2013 PROPOSED CHANGES TO THE INTERNATIONAL MECHANICAL/PLUMBING CODE

INTERNATIONAL MECHANICAL/PLUMBING CODE COMMITTEE

TENTATIVE ORDER OF DISCUSSION 2013 PROPOSED CHANGES TO THE INTERNATIONAL RESIDENTIAL CODE – MECHANICAL

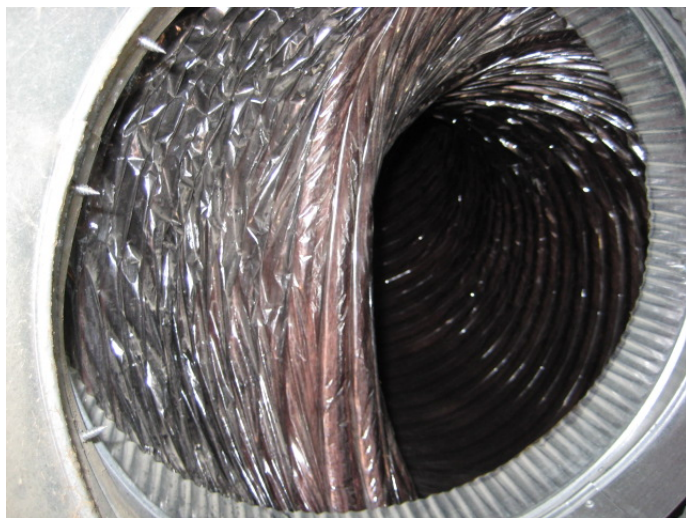
Reason: National homebuilders are making this opening only 32 inches wide. This is not wide enough for the supply and return air ducts to have a straight run through the wall from the supply and return ports on the HVAC unit.

When the air ducts have to veer sharply in one direction after they come off of the port in order to get to the opening in the wall, airflow is restricted inside the duct. NOTE: the ports open straight forward, facing the wall of the house. When the duct veers, it blocks the opening of the port. The ducts need a straight run.

Three (3) photos are attached to this proposal form. (photos were taken at my residence, after rain hood was removed from the HVAC unit)

The opening in the foundation wall is not wide enough for the HVAC unit.

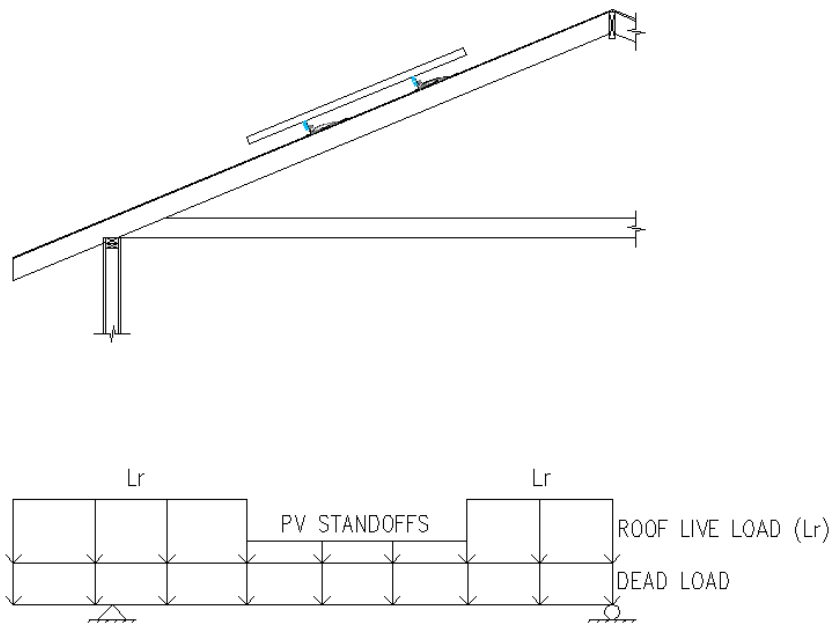
The first sentence of M2302.3.1 clarifies the system of hardware that becomes the mounting system for rooftop-mounted photovoltaic panel systems must be qualified by methods found in the International Building Code. There are no applicable provisions found in the International Residential Code for these systems of mounting hardware. These mounting systems must be qualified by calculations or physical testing, as prescribed in the IBC. New definitions are needed to provide this clarity.

The second sentence of M2302.3.1 clarifies the roof system must be checked or designed to support the resultant loads imposed on it by the mounting system of the photovoltaic panel system. This check can be accomplished by using appropriate span tables in IRC Chapter 8, or by structural analysis according to IBC provisions.

A new section on wind load is added for guidance to appropriate codes and standards where wind design provisions are found. Effective Wind Area is defined in ASCE 7-10 Section 26.2. Effective Wind Area is also referenced in Footnote a of Table R301.2(2) of this code. Effective Wind Area used in design of photovoltaic systems must be consistent with the definition found in ASCE 7 in order to be compatible with the wind design calculation methods found in ASCE 7.
